UNITED STATES PATENT AND TRADEMARK OFFICE

10/595,460

Jangshik Yun

Office Action Summary	Application No. 10/595,460	Applicant(s) YUN, JANGSHIK	
	Examiner IVES WU	Art Unit 1797

FIGURE 1

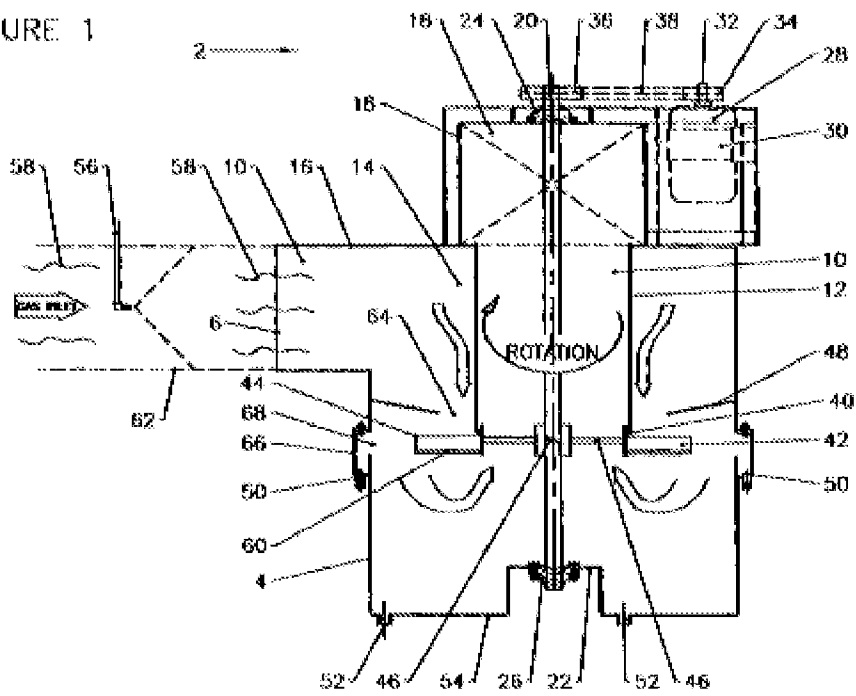
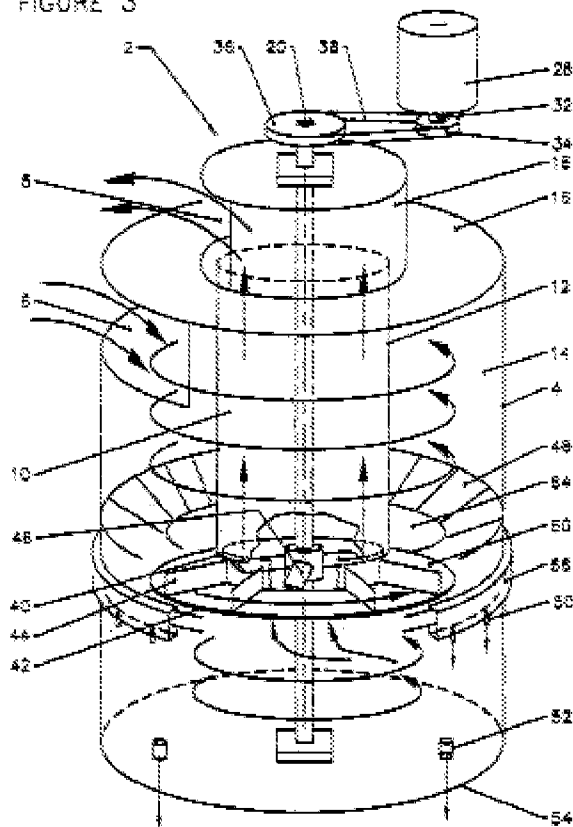
As to wet type air cleaner utilizing a centrifugal impeller comprising: a body 407 in which a centrifugal impeller 408 rotates the sucked air, to which a housing and a gas passage cylinder 413 are mounted so that a vortex having a centrifugal force lengthwisely passes by a predetermined distance in **independent claim 14**, Rosen (US 7077886B2) discloses emission control device and method of operation thereof (Title). It relates to an emission control device to remove particulates from a gas and, more particularly to an emission control device that operates by adding moisture to the gas and subsequently removing moisture from the gas along with particulates. Still more particularly, it relates to a scrubber with a fan located therein (Col. 1, line 10-15). As is shown in the Figure below, it has housing 4; blower (fan) 42; passage 10; which meet the limitations as claimed.

As to the body having an annular 1st vortex room formed between the housing 409 and the gas passage cylinder 413 and a 2nd vortex room formed in the gas passage cylinder 413 in **independent claim 14**, as shown in the Figures above the annular passage which reads on the 1st vortex room, the passage 10 within the concentric section reads on 2nd vortex room.

As to over driver 436 utilizing with various transfer means including an oil surface friction transmission, a gear transmission et al for increasing the rotation speed of a centrifugal impeller 408 in **claim 17**, Rosen (US 7077886B2) discloses the belt 38, pulleys 34, 36 to drive the shaft 20 of the fan as shown in the Figure of Rosen (US 7077886B2) above.

As to a scrubbing room 406 located on the gas suction duct 405 for scrubbing gas pollutants with the stream of a fine particular liquid mist in **claim 18**, as shown in Figure above the section before the gas inlet passage 10 would be a scrubbing section.

As to a centrifugal impeller 408 utilizing with a turbine impeller for generating centrifugal vortex stream in a gas-liquid centrifugal separator 407 in **claim 23**, as shown in the Figure of Rosen above, the outer blades 44 reads on the limitations as claimed.

As to wet type air cleaner utilizing a centrifugal impeller with a liquid atomizer and a gas-liquid centrifugal separator for disposing an electric motor outside of a gas-liquid centrifugal separator comprising: an electric motor 433 installed on the outside of a gas-liquid centrifugal separator 407, an over driver 436 connected with an electric motor 433, an impeller shaft 435 rotatably fixed with an over driver 436, a centrifugal impeller 408 rotatably fixed on an impeller shaft 435, and a bearing 434 supported for a centrifugal impeller 408 on a gas passage cylinder 413 in **claim 24**, as shown in the Figure above, moisturizer 56, emission control device 2, the motor 28, pulley 34, belt 38, shaft 20, bearing 24, blower 42, gas passage 10, which read on the limitations as claimed.

As to an impeller shaft 435 formed with a gas passage inside for passing a clean gas through inside of a shaft in **claim 25**, as shown in the Figure above, the shaft 20 and gas passage 10, which reads on limitations as claimed.

As to spiral grooves 416 formed on the outside surface of a gas passage cylinder 413 for generating vortex stream of wet gas on the basis of labyrinth effect and separating washing water from gas on the basis of centrifugal force in claim 16, Rosen (US 7077886B2) discloses the annular baffles at lower end of annular passage as shown in the Figure 4 above. Rosen **does not teach** the spiral grooves as claimed.

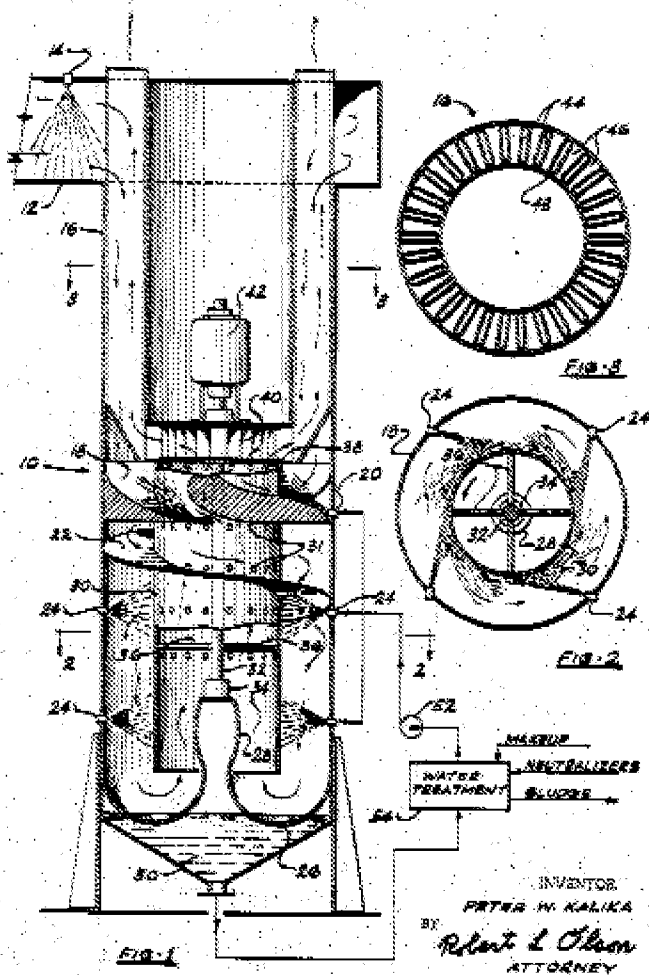
However, Kalika (US 3358413) **teaches** wet scrubber for dirty gases (Title).
As illustrated in the Figure below, the spiral baffle 22 which reads on limitations as claimed.

The advantage of spiral baffles is to further stabilize and ensure the spiral flow pattern (Col. 2, line 16-17).

Therefore, it would have been obvious at time of the invention to install the spiral groove disclosed by Kalika for the annular passage in the device of Rosen in order to attain the advantage cited herein above.
